**TOWNSHIP OF SOUTH WHITEHALL
LEHIGH COUNTY, PENNSYLVANIA**

PLANNING COMMISSION

APRIL 15, 2021

TO: PLANNING COMMISSION
FROM: GREGG ADAMS, PLANNER
**SUBJECT: NESTLE PURINA WASTEWATER TREATMENT UPGRADES
MAJOR PLAN 2021-102
REQUEST FOR PRELIMINARY/FINAL PLAN REVIEW**
DATE: APRIL 12, 2021
**COPIES: BOARD OF COMMISSIONERS, R. BICKEL, D. MANHARDT, L. HARRIER,
A. SILVERSTEIN, J. ZATOR, ESQ., J. ADLERFER, ESQ, S. PIDCOCK,
APPLICANT, SUB. FILE 2021-102**

EXISTING FEATURES & SITE ANALYSIS PLAN
 WASTEWATER TREATMENT UPGRADES

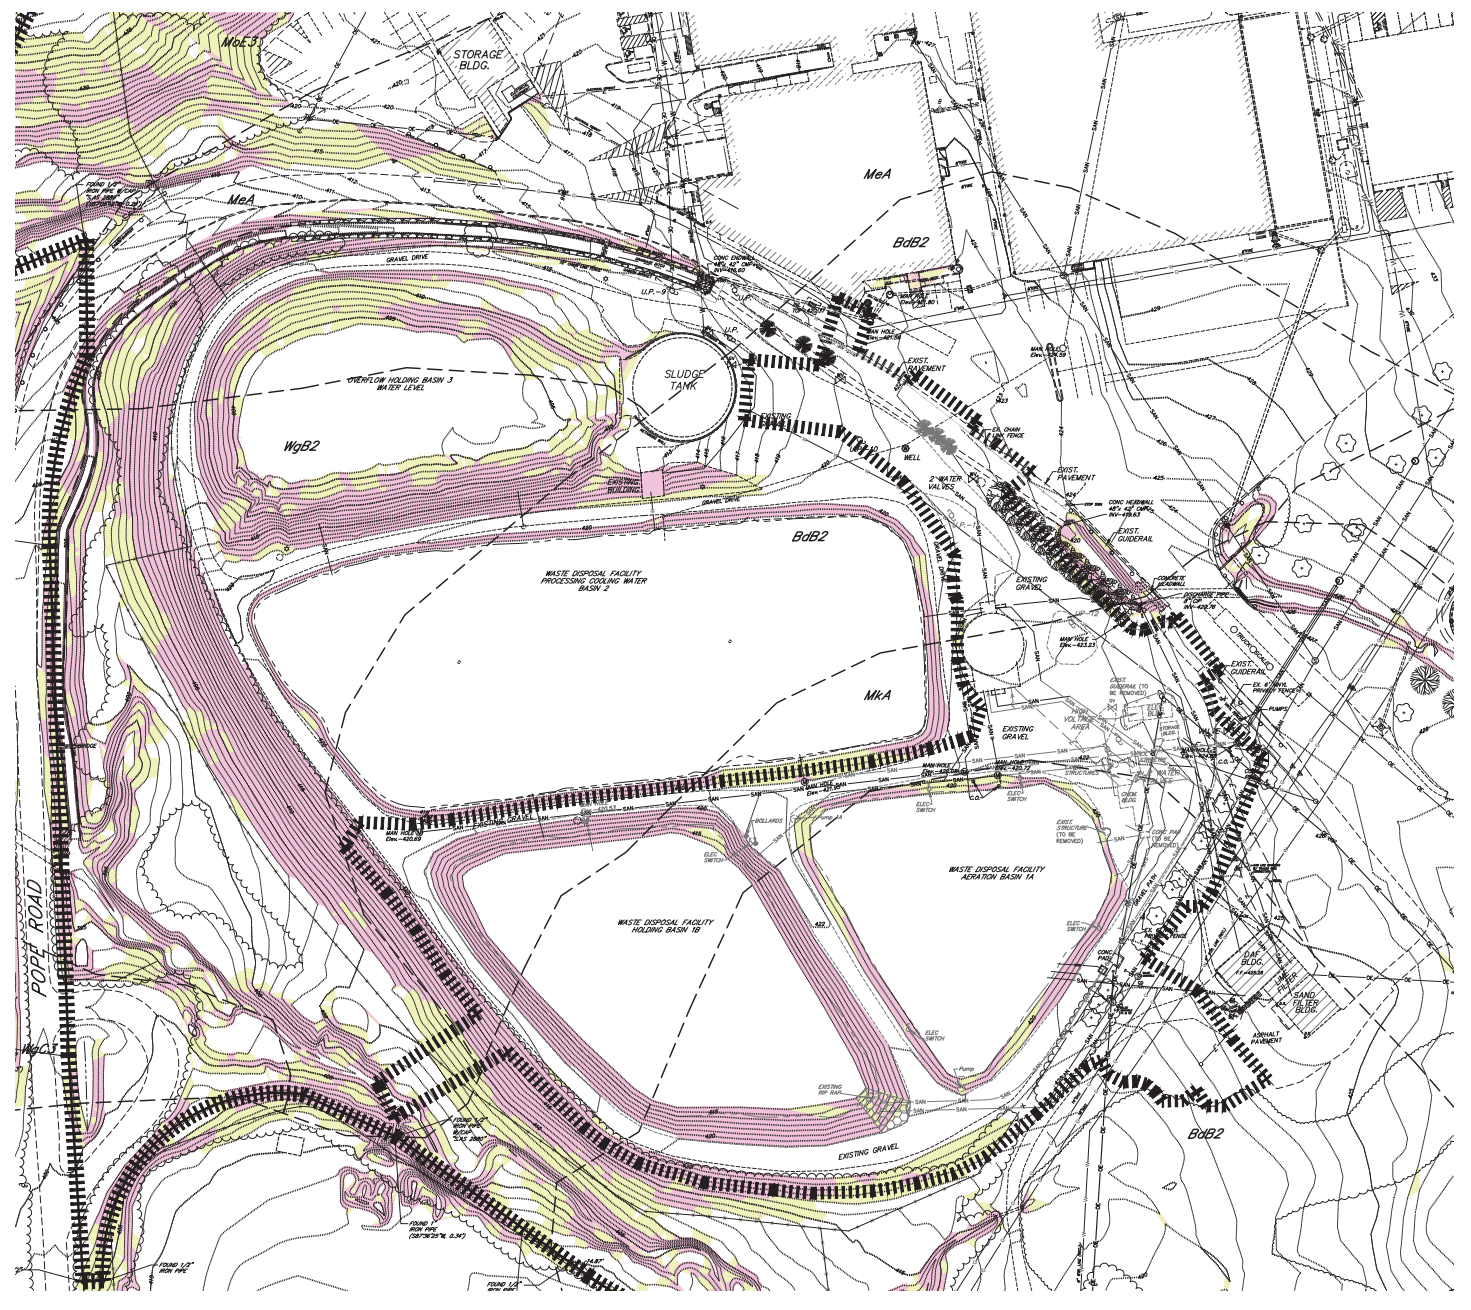
5. The Narrative shall be signed and sealed by the licensed professional responsible for preparing it.
6. On Plan Sheet 3 of 10, Site Analysis Note Block, Site Factors Inventory Note a.3 states "possible carbonate bedrock". This conflicts with other project information which states that the site is underlain by carbonate bedrock. This note shall be revised to reflect this.

7. On Plan Sheet 3 of 10, Site Analysis Note Block, Site Factors Analysis Notes 'e' and 'f' state that this project is exempt from Act 167 Plan requirements and from Township Stormwater Management Ordinance requirements "due to no increase in impervious area". The plans indicate that the ground cover at the location of the proposed building is "existing gravel". The consultant shall provide clarification regarding the impervious nature of this cover. Stormwater Ordinance Chapter 296-5.E provides for an exemption for projects that create 10,000 square feet or less of additional impervious cover. However, development plans qualifying for this waiver would still be required to manage the quantity, velocity, and direction of resulting stormwater runoff as is reasonably necessary to prevent injury to health, safety, or other property.

DWG. No. 671-2114-SP01
 B/E#: 2020142-SP01
 SHEET 1 of 10

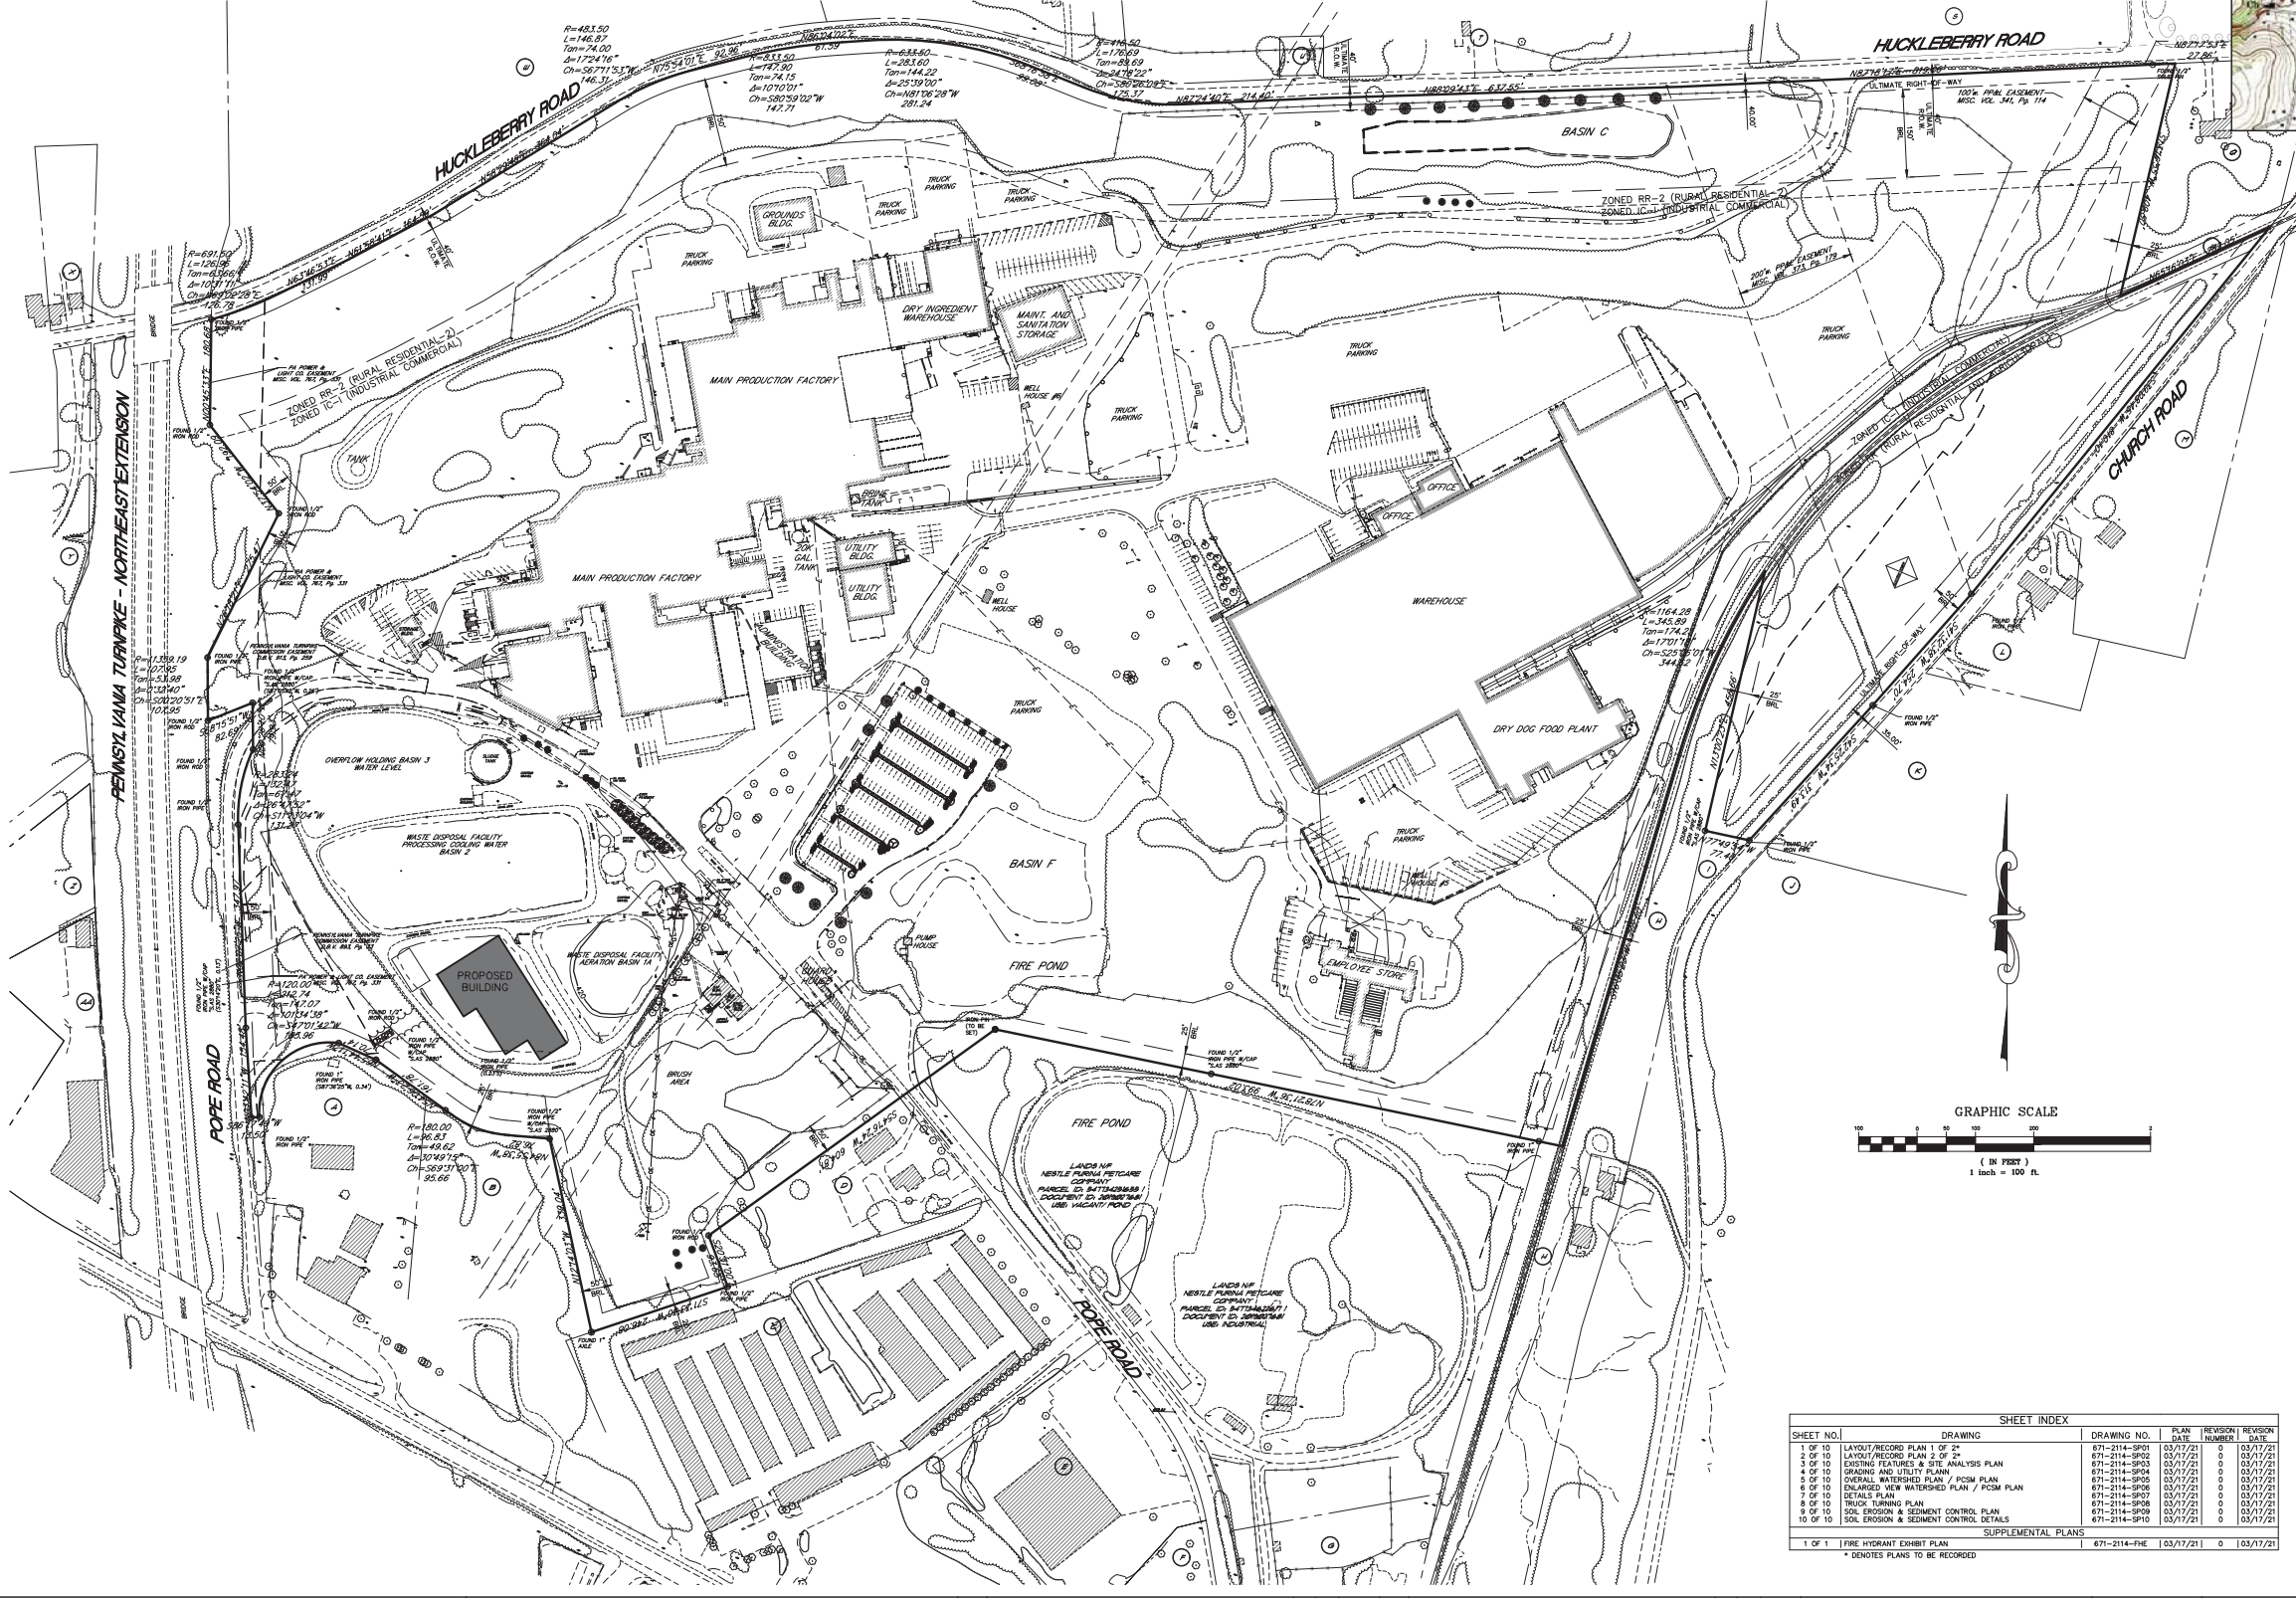
9. On Plan Sheets 1 of 10 and 2 of 10, it appears that the signatures and seals of the engineer and surveyor are reversed in the signature blocks.
